Access Compliance Report

Public Rights-of-Way

(Curb Ramps)

Intersection ID: 5923	Main Street: FOREST_POND_DR	Cross Street: WILD_BERRY_CT	Location: SE
ADA ID: 6FB356280E5B	Ramp Type: Perp	Initial Pass/Fail: Fail	Overall Compliance: No
Severity Score: 22.5			
Codes/Mitigation Info/Possible Solution		Field Measurements/Component Compliance

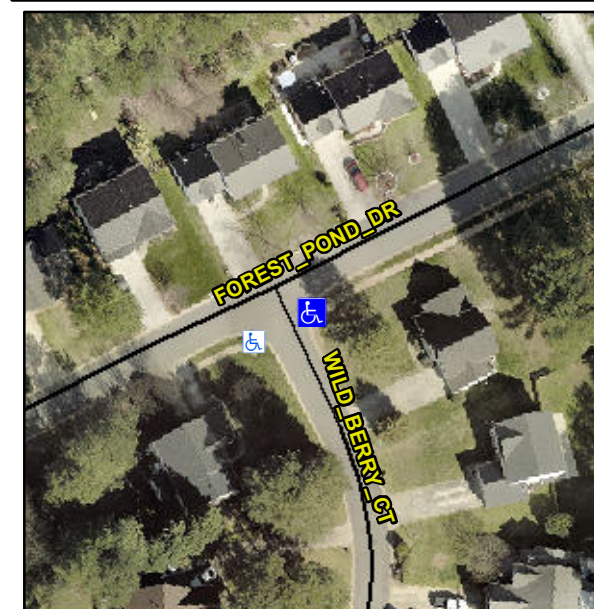
Not Found, R304.5.1, R304.2.2, R304.5.3

Compliance	Description	Data	Compliance	Description	Data
N/A	Ramp Length (in)	95.0	No	Ramp Slope (%)	8.6
No	Ramp Width (in)	45.0	No	Ramp XSlope (%)	2.4
N/A	Flare Type LT	N/A	N/A	Flare Type RT	N/A
N/A	Flare Slope LT (%)	N/A	N/A	Flare Slope RT (%)	N/A
N/A	Flare Traversable LT?	N/A	N/A	Flare Traversable RT?	N/A
N/A	Landing Length (in)	N/A	N/A	DWS Provided?	N/A
N/A	Landing Width (in)	N/A	N/A	DWS Contrast?	N/A
N/A	Landing Slope (%)	N/A	N/A	DWS Length (in)	N/A
N/A	Landing X Slope (%)	N/A	N/A	DWS Full Width?	N/A
N/A	Landing Curb? (Y/N)	N/A	N/A	DWS Offset (in)	N/A
N/A	Shared Landing?	N/A			
N/A	Gutter Ponding?	N/A	N/A	Gutter Slope (%)	N/A
N/A	Gutter Lip Ht (in)	0.75	N/A	Gutter X Slope (%)	N/A
N/A	Painted X Walk1?	No	N/A	Painted X Walk2?	N/A
	X Walk 1 Direction	To W		X Walk 2 Direction	N/A
N/A	X Walk 1 Width (in)	N/A	N/A	X Walk 2 Width (in)	N/A
	X Walk 1 Slope (%)	0.7		X Walk 2 Slope (%)	N/A
	X Walk 1 X Slope (%)	3.3		X Walk 2 X Slope (%)	N/A

Remove & Replace Entire Ramp.
